Open Rack Project Session

Proposals for Open Rack Standard V1.2

Compute Summit

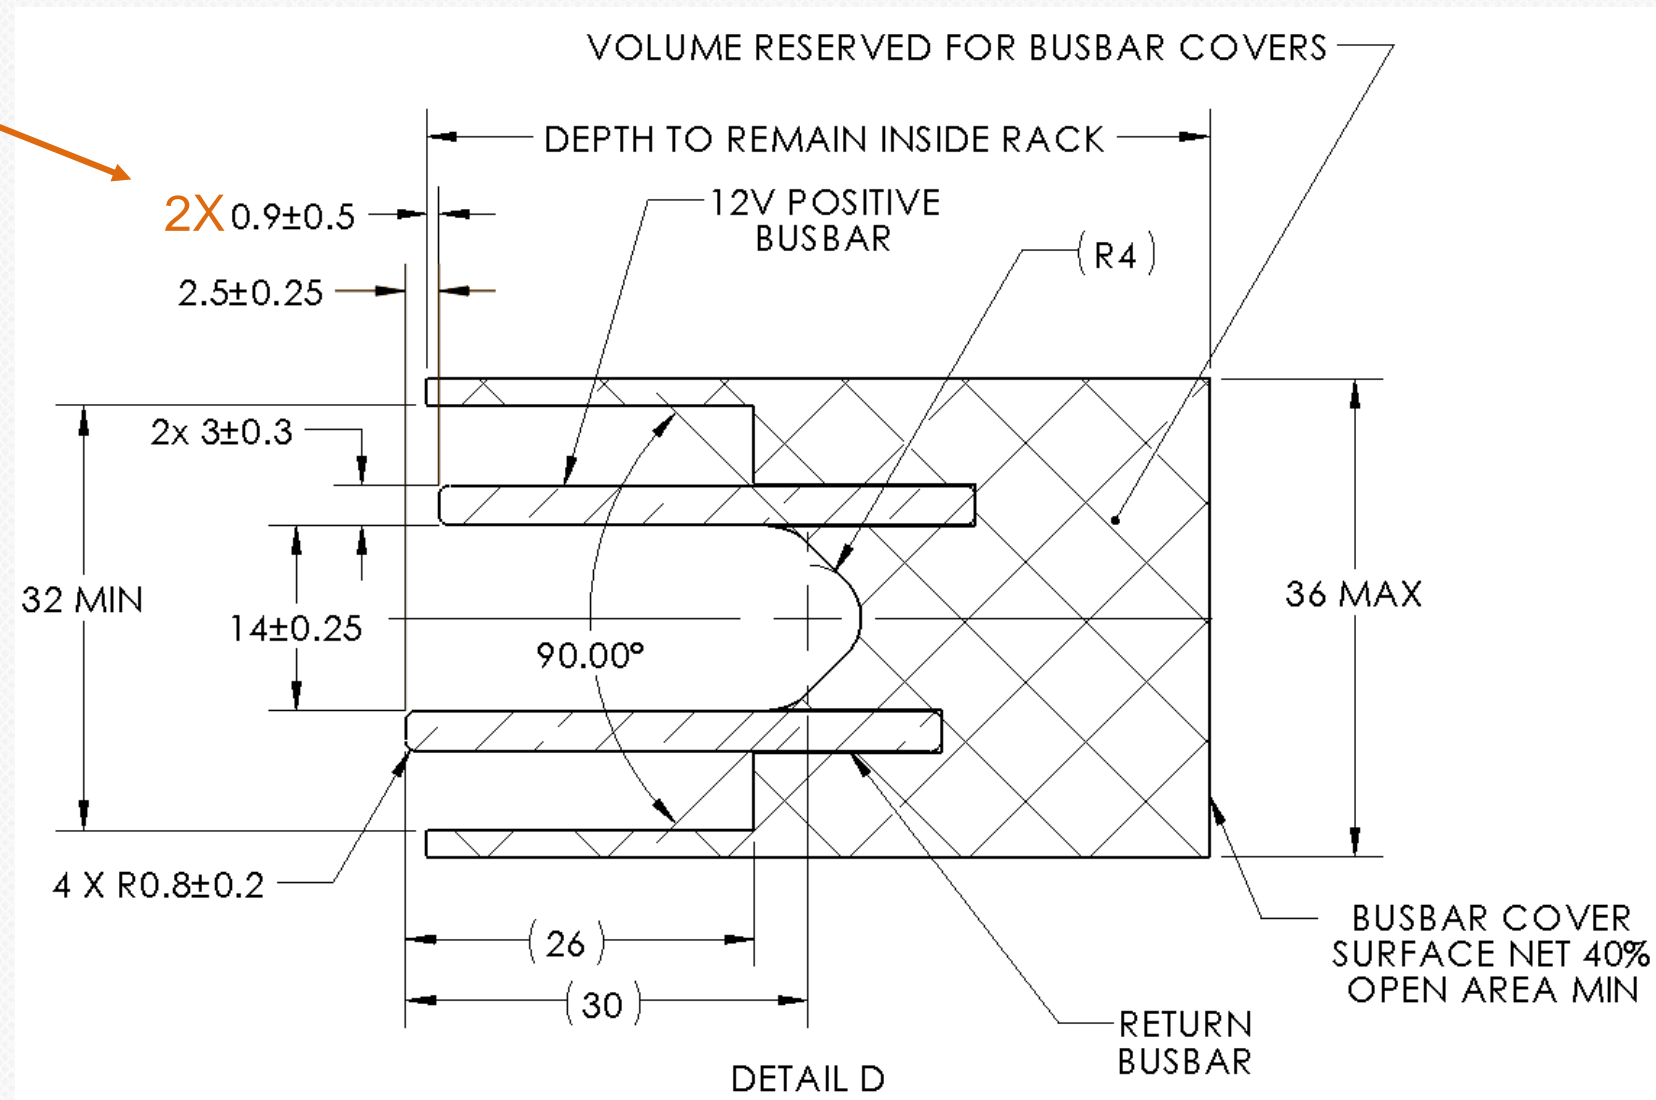
Define Standardized interface for the power system to connect to the busbars

Start with Hole at Datum E and add holes to the busbar in a 25x25 array

Add 2X to 0.9 dimension controlling the busbar cover

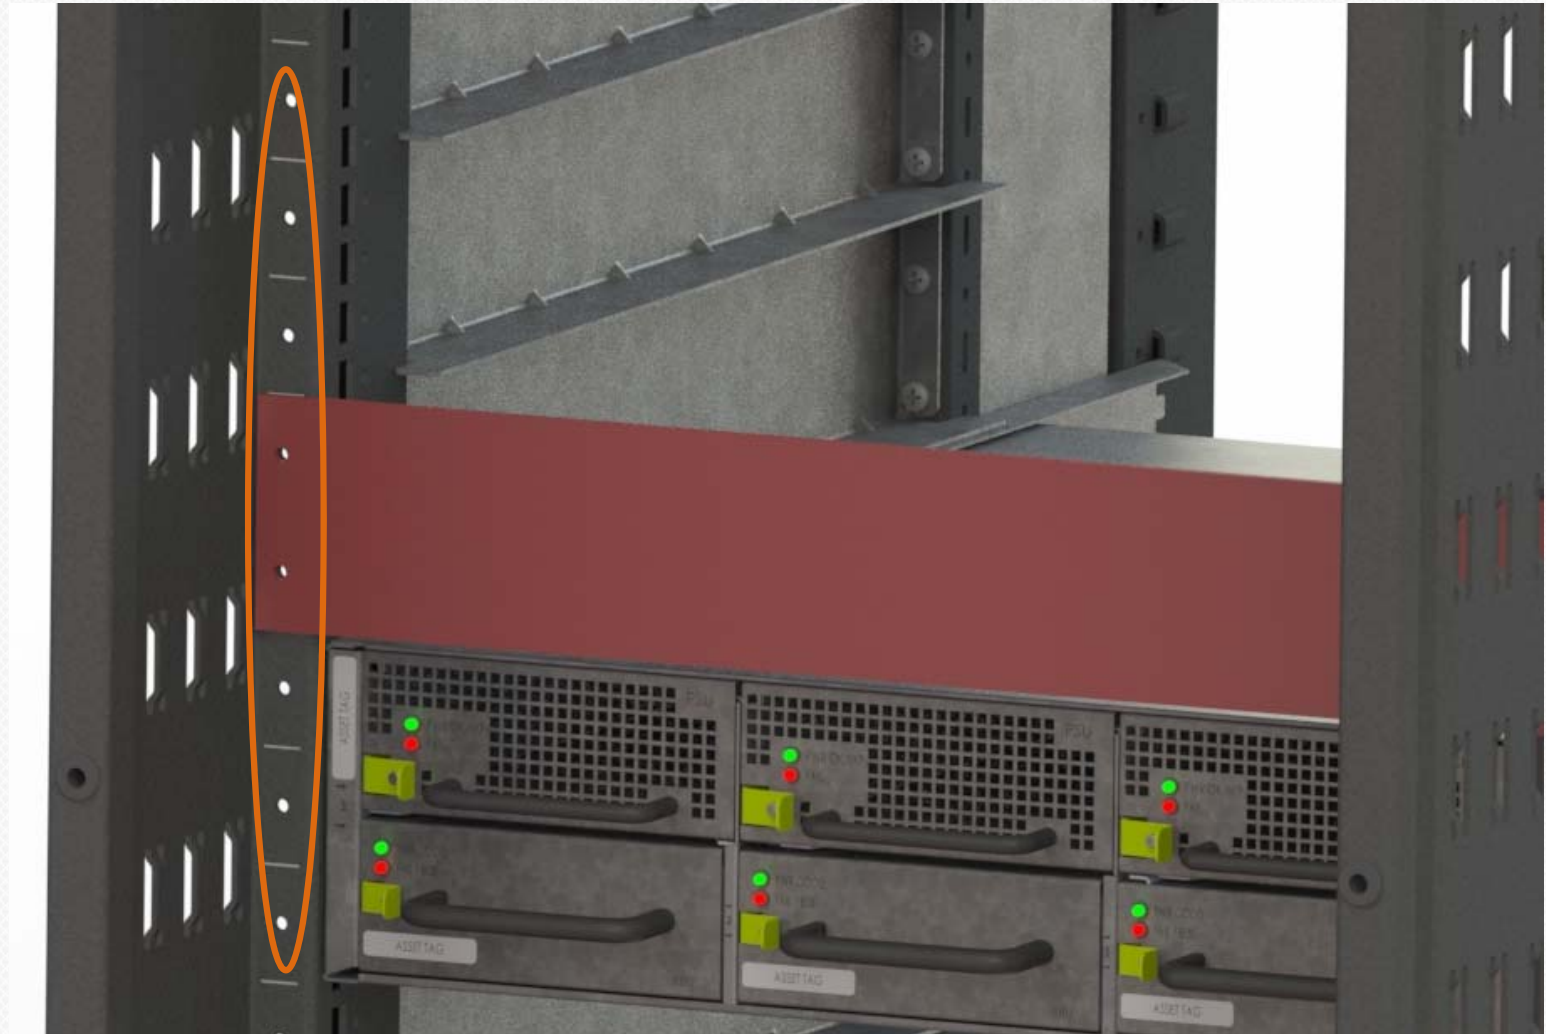
Add holes for flat close-out panels

Add a series of 5.5mm holes for thread forming screws or plastic push rivets every 10U to the front vertical posts.

Makes it easy to install flat air containment panels across the front of the rack
